RIDGE RACER V

TWIN AND UPRIGHT

TECHNICAL UPDATE

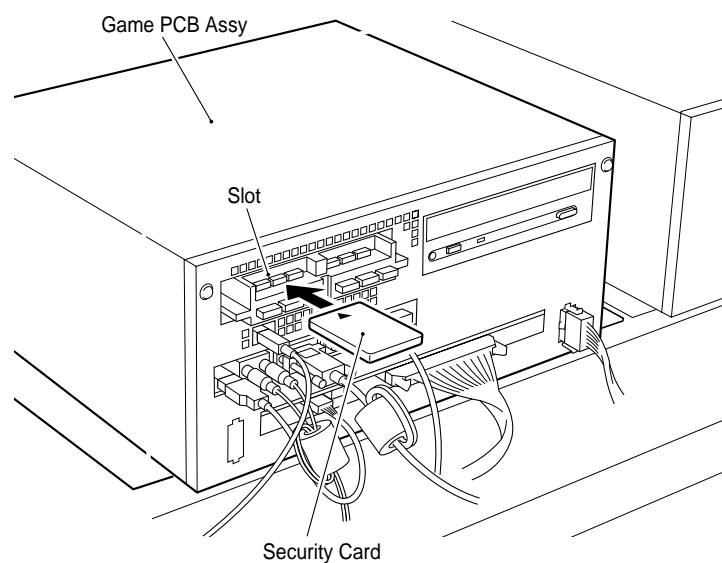
- 1 Remove the monitor cabinet lower rear door.
2. Remove the old security card by pulling it directly out from the game pcb Assy.

- 3 Insert the new security card with the arrow upwards into the left slot. Push the security card until it is fully connected to the slot connector.
4. Refit the rear door.
